11-AFC-2

**RE: HIDDEN HILLS SOLAR ELECTRIC GENERATING SYSTEM
APPLICATION FOR CERTIFICATION**

Please accept the following submission, "Preliminary Public Comments, Technical Analysis & Recommendations" regarding the Application for Certification of the Hidden Hills Solar Electric Generating System.

Source: 2011-12-30 Data Response Set: 1B-2 TN-63262, Appendix A, Figures, pp. 47.

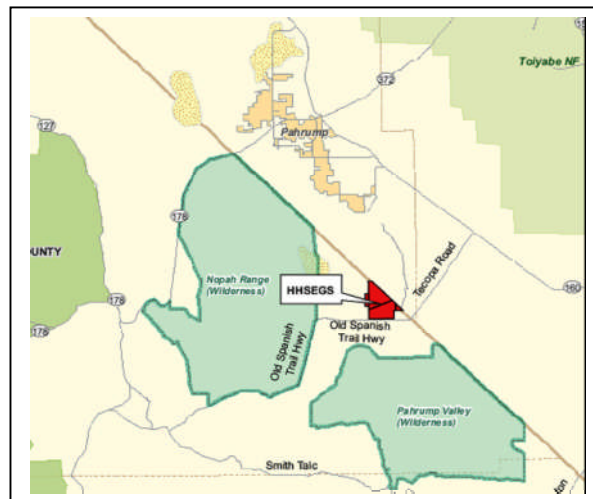
The HHSEGS project site is nearby the Pahrump Valley Wilderness, which should qualify as a Class I designation.

- Provide a Table that addresses PSD Maximum Allowable Class I significant impact levels.

Figure 3, Flood Plain Map, Appendix 5.2E, pp.28, Jurisdiction Wetlands

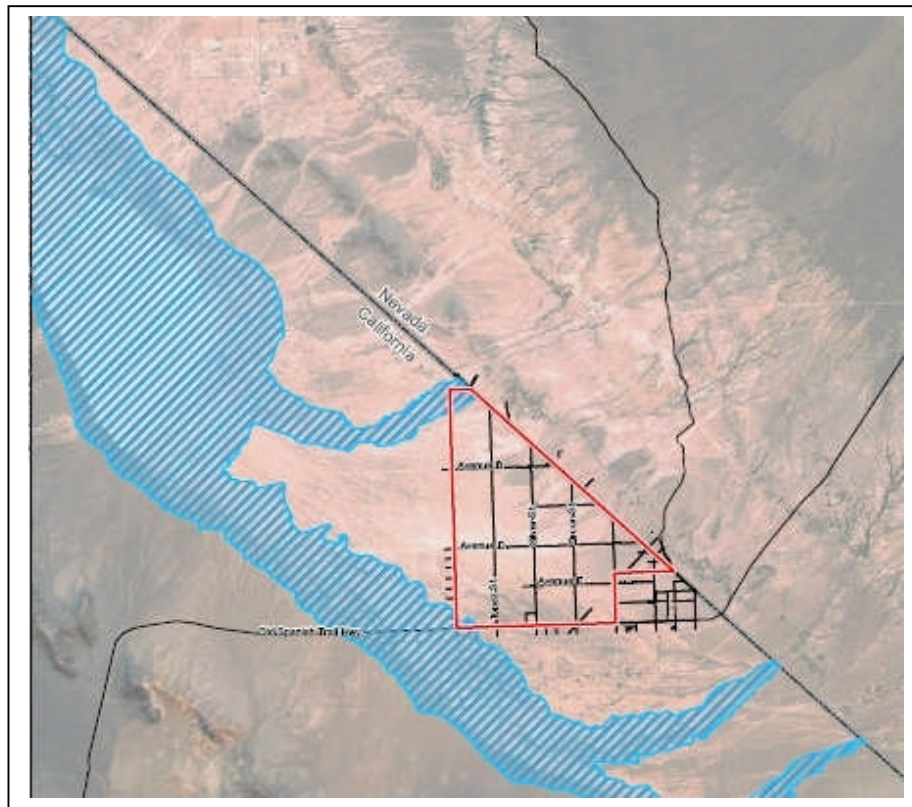
Though it *is* clear that the HHSEGS project site will be built at the base of an alluvial fan, it is *not* clear where specifically the California/Nevada border crosses through the areas highlighted in the photos below or to what extent, if any, Bright Source will grade, fill, level or destroy any of this unique landscape in efforts to reduce stormwater impacts and flooding.

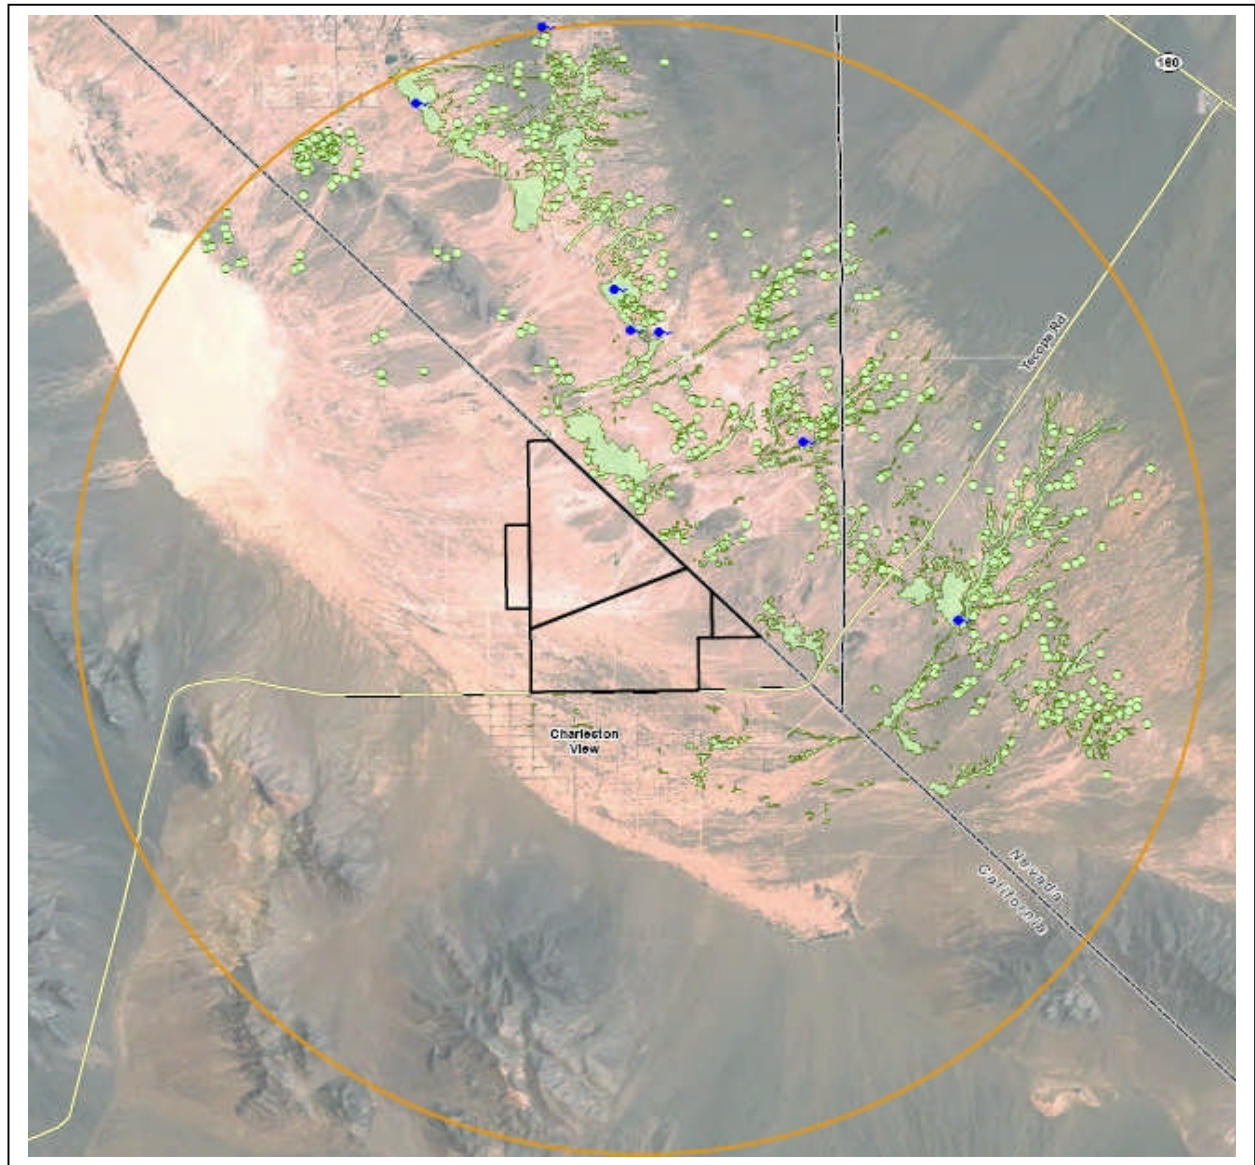
"Mesquite is the most abundant groundwater-dependent vegetation in the study area.⁶ Mesquite have deep root systems that can extend more than 100 ft below the surface. Quade et al. (1995) note that the mesquite trees of the Pahrump Valley "mark water depths of ~5-20m" (16 to 66 feet). The mesquite on coppice dunes and in arroyos along the Stateline fault system occur at a locally shallow water table." (pp. 44)

"With respect to groundwater dependent vegetation: There are only a handful and none currently flow, although shallow-groundwater dependent vegetation survives near all. This vegetation, dominated by mesquite, generally shows more dieback closer to Pahrump." (pp.42).

9. DESERT TORTOISE: HABITAT RANK

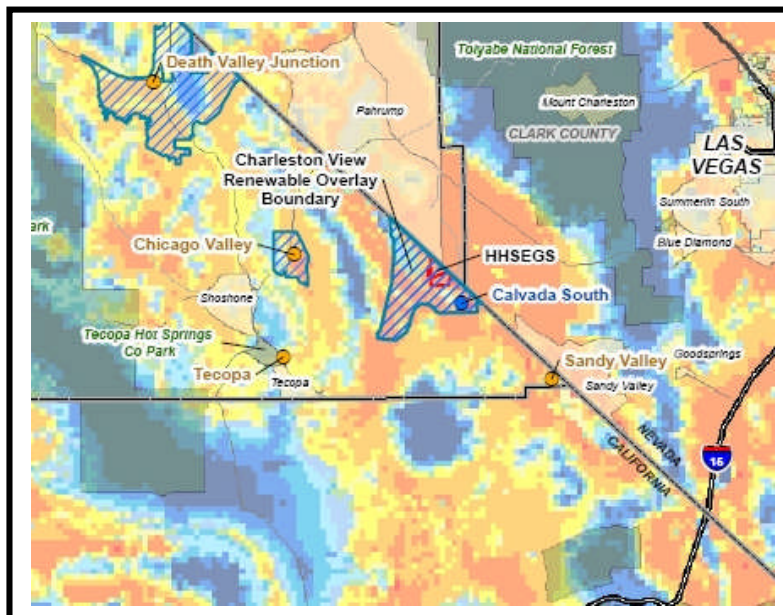
In Section 6.0, Alternatives, pp. 9, the applicant describes why the proposed HHSEGS site was chosen over alternative sites:

“The site has special-status plants, but contains low density populations of desert tortoise and low-quality tortoise habitat.” (Emphasis added.)
